# Intel<sup>®</sup> Pentium<sup>®</sup> 4 Processor Specification Update

Release Date: October 2001

Order Number: 249199-014

The Intel<sup>®</sup> Pentium<sup>®</sup> 4 processor may contain design defects or errors known as errata which may cause the product to deviate from published specifications. Current characterized errata are documented in this Specification Update.

The following figure will be added as Figure (new). THERMTRIP# Power Down Sequence

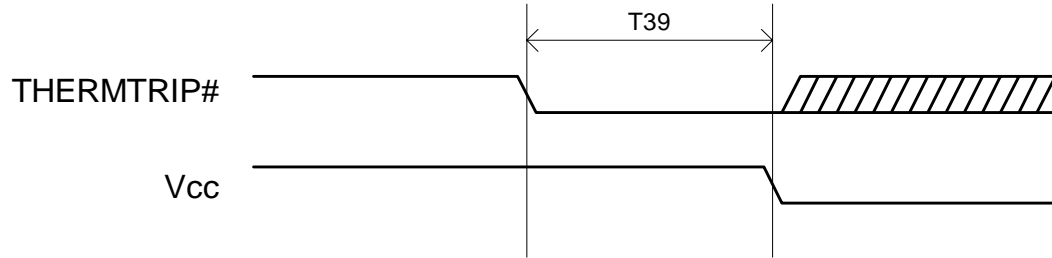
### N3. THERMTRIP# Clarification

Several parts of the *Intel® Pentium® 4 Processor in the 423-pin Package* datasheet will be updated as follows to clarify the functionality of the Thermtrip# pin.

The description of THERMTRIP# in Table 32, page 69 will now state:

Assertion of THERMTRIP# (Thermal Trip) indicates the processor junction temperature has reached a level beyond which permanent silicon damage may occur. Measurement of the temperature is accomplished through an internal thermal sensor which is configured to trip at approximately 135°C. Upon assertion of THERMTRIP#, the processor will shut off its internal clocks (thus halting program execution) in an attempt to reduce the processor junction temperature. To protect the processor, its core voltage ( $V_{CC}$ ) must be removed following the assertion of THERMTRIP#. See Figure (new) and Table 13 for the appropriate power down sequence and timing requirements. Once activated, THERMTRIP# remains latched until RESET# is asserted. While the assertion of the RESET# signal will de-assert THERMTRIP# , if the processor's junction temperature remains at or above the trip level, THERMTRIP# will again be asserted after RESET# is de-asserted.

The following specification will be added to Table 13, page 24.

<u>T# Parameter</u>	<u>Min</u>	<u>Max</u>	<u>Unit</u>	<u>Figure</u>	<u>Notes</u>
T39: THERMTRIP# to removal of power	N/A	500	ms	(new)
